**From:** Pederson Ronda M (AREVA NP INC) [Ronda.Pederson@areva.com]  
**Sent:** Friday, February 27, 2009 5:46 PM  
**To:** Getachew Tesfaye  
**Cc:** DELANO Karen V (AREVA NP INC); BENNETT Kathy A (OFR) (AREVA NP INC); KOWALSKI David J (AREVA NP INC)  
**Subject:** Response to U.S. EPR Design Certification Application RAI No. 174, FSAR Ch. 9  
**Attachments:** RAI 174 Response US EPR DC.pdf

**Subject:** U.S. EPR Design Certification Application RAI No. 174 (1806, 1810),FSAR Ch. 9

**QUESTIONS for Balance of Plant Branch 1 (AP1000/EPR Projects) (SBPA)**

Figure 2.7.1-1—Component Cooling Water System Functional Arrangement  
Sheet 2 of 24

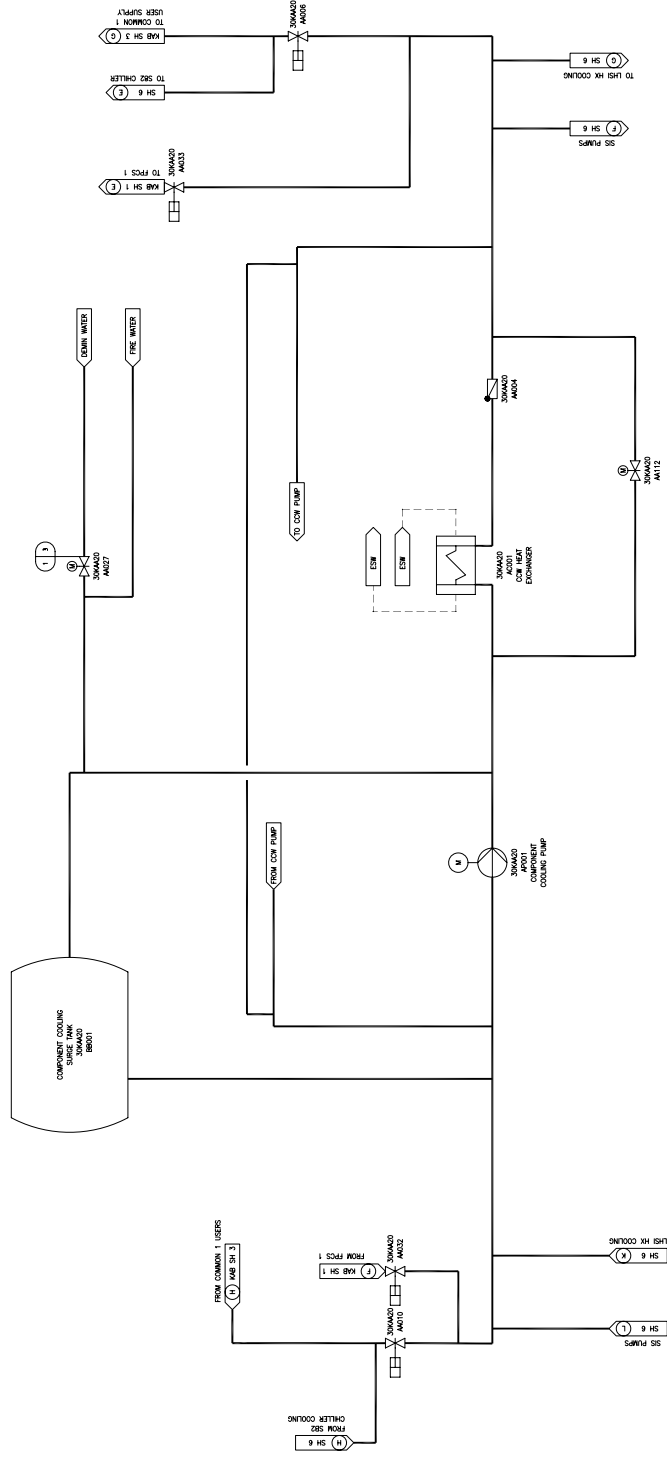
- d. Describe in the FSAR the source of emergency makeup and its seismic qualification. FSAR Figure 9.2.2-1 indicated that the emergency makeup was provided by the Fire Protection system; however, FSAR Section 9.2.2 states that the emergency makeup was provided by the "water distribution system (FWDS)". Provide in the FSAR the basis for any emergency makeup power and justify that it is a manual operation to provide water to the surge tanks.

U.S. EPR FSAR Tier 1, Figure 2.7.1-1—Component Cooling Water System Functional Arrangement, Sheets 1 through 4, and U.S. EPR FSAR Tier 2, Figure 9.2.2-1—Component Cooling Water System Trains 1 through 4 will be revised to depict these valves as MOVs.

REVISED PER QUESTION 09.02.02-10(C)
